ITEM FOR ENVIRONMENTAL COMMISSION AGENDA

COMMISSION MEETING DATE:	December 2, 2020
NAME & NUMBER OF PROJECT:	SP-2020-0228D Brushy Creek Regional Utility Authority Raw Water Pump Station
NAME OF APPLICANT OR ORGANIZATION:	Karen Bondy, General Manager Brushy Creek Regional Utility Authority
LOCATION:	9416 Lime Creek Road, Leander, Texas 78641
COUNCIL DISTRICT:	Council District does not apply in Extraterritorial Jurisdiction
ENVIRONMENTAL REVIEW STAFF:	Jonathan Garner, Environmental Program Coordinator, Development Services Department, (512) 974-1665, Jonathan.Garner@austintexas.gov
WATERSHED:	Lake Travis Watershed, Water Supply Rural Classification, Drinking Water Protection Zone
REQUEST:	<p>Variance requests are as follows:</p> <ol style="list-style-type: none">1. Request to vary from LDC 25-8-301 to construct private driveways crossing slopes in excess of 15 percent gradient.2. Request to vary from LDC 25-8-302(A) to construct a surface parking lot on slopes in excess of 15 percent gradient.3. Request to vary from LDC 25-8-302(B) to construct a building on slopes in excess of 25 percent gradient, and exceed impervious cover allowance on slopes with a gradient of more than 15 perce

OVERALL EXISTING CONDITIONS

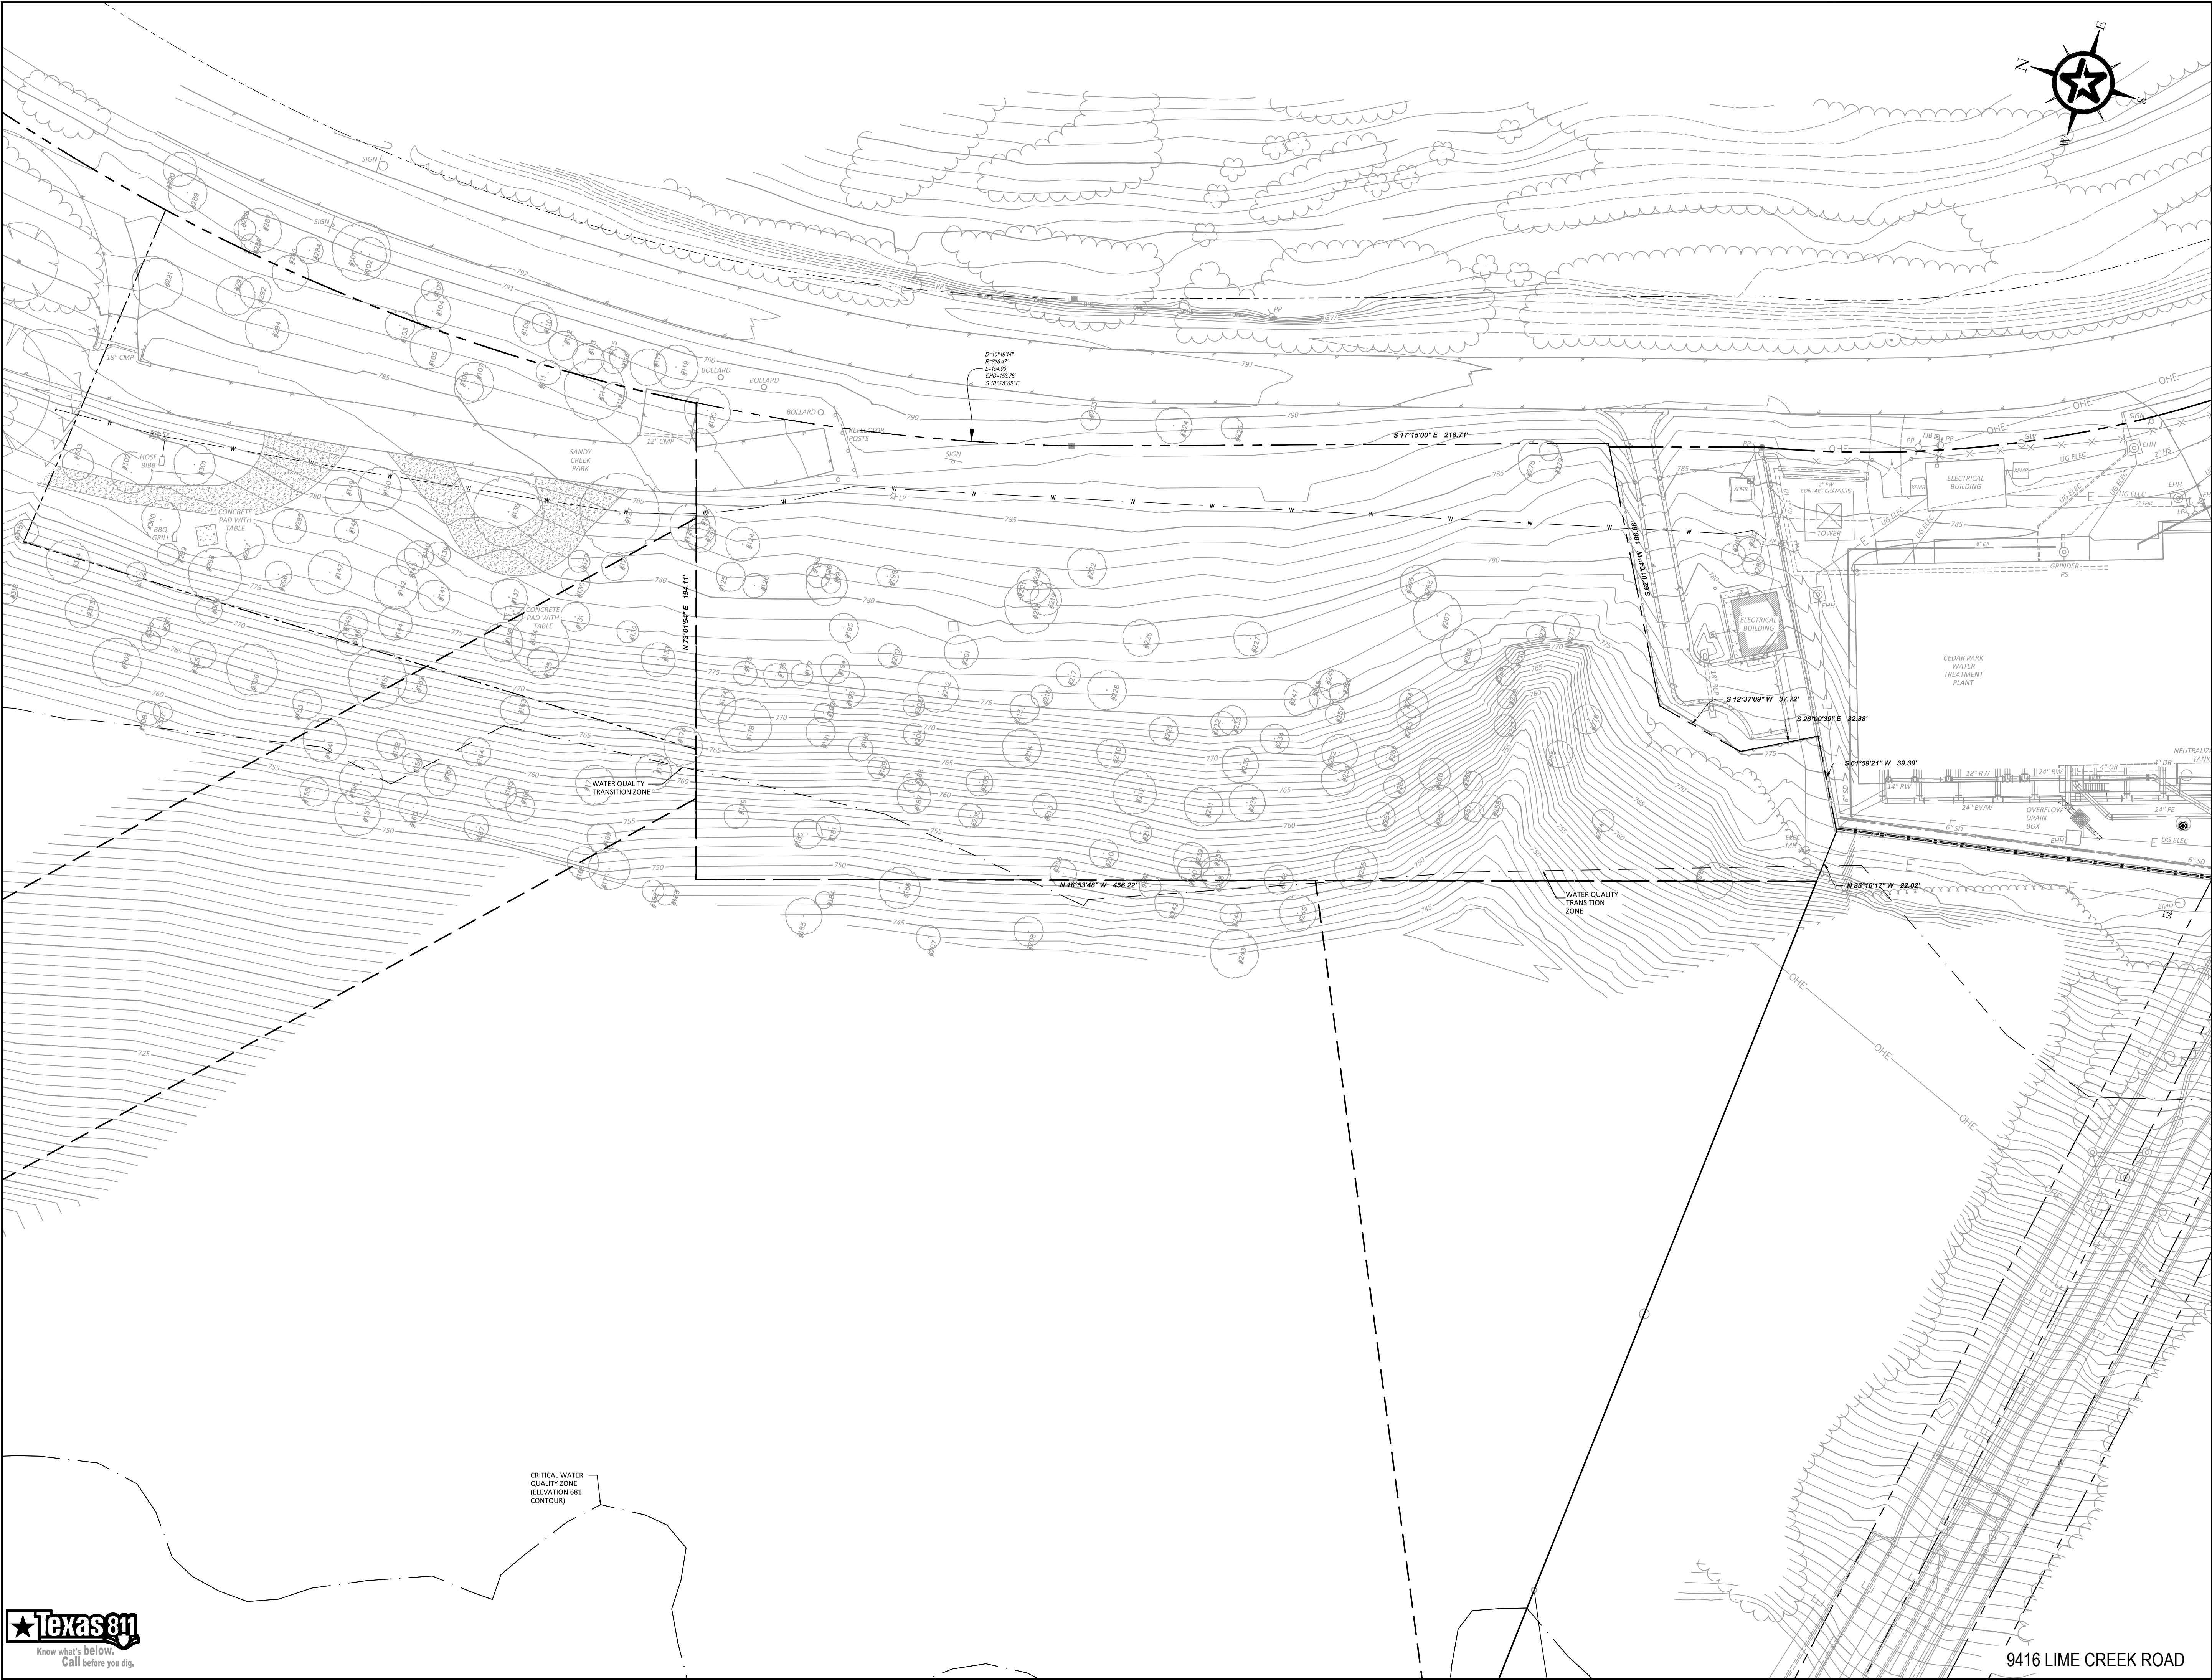
Yes. All the proposed construction on the site requiring the variances is necessitated by the scale of the property and the site constraints of the existing topography (see Overall Existing Conditions exhibit, page 33). The relative small area of the site is due to the parceling of the site by LCRA, and is the only property along Lake Travis that was conveyed to BCRUA for this facility.

DIMENSIONED SITE PLAN

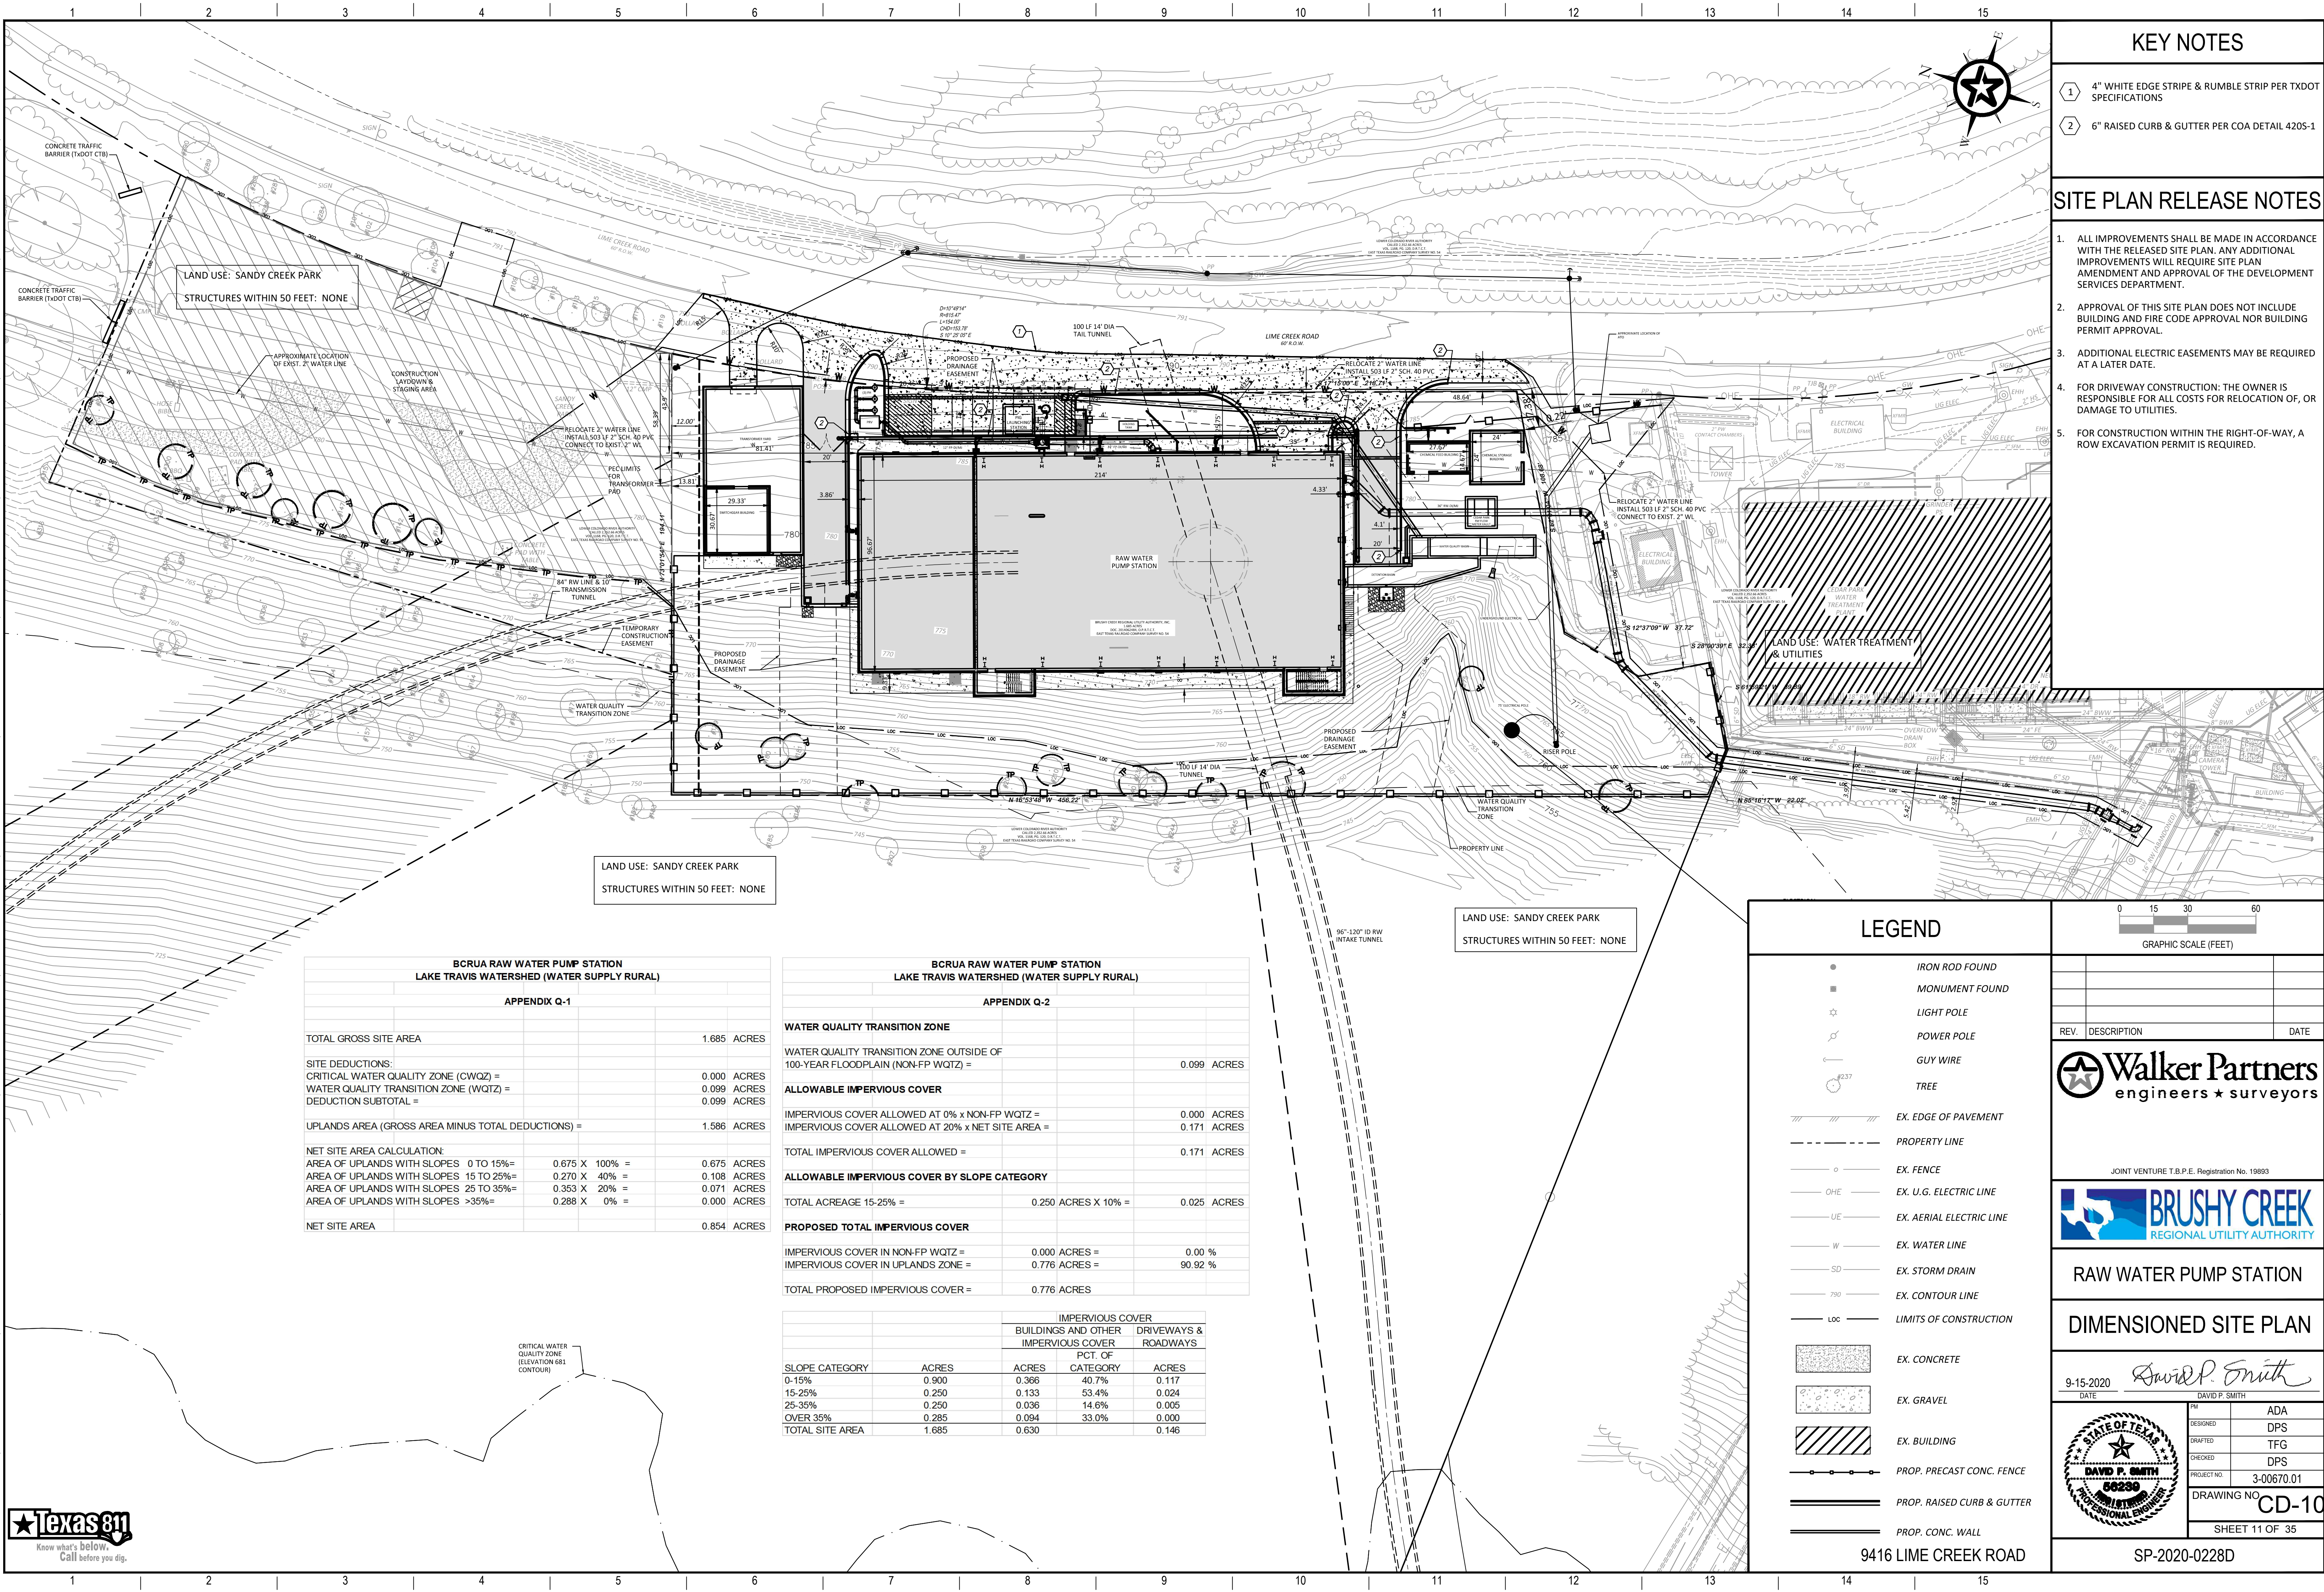
Despite the topographic challenges of the property, the site plan provides for greater overall environmental protection by reducing the amount of parking spaces, drive/fire lanes, and fill to construct these features to only the minimum required for the functioning of the facility or that allowed by Travis County fire regulations (see Dimensioned Site Plan exhibit, page 34).
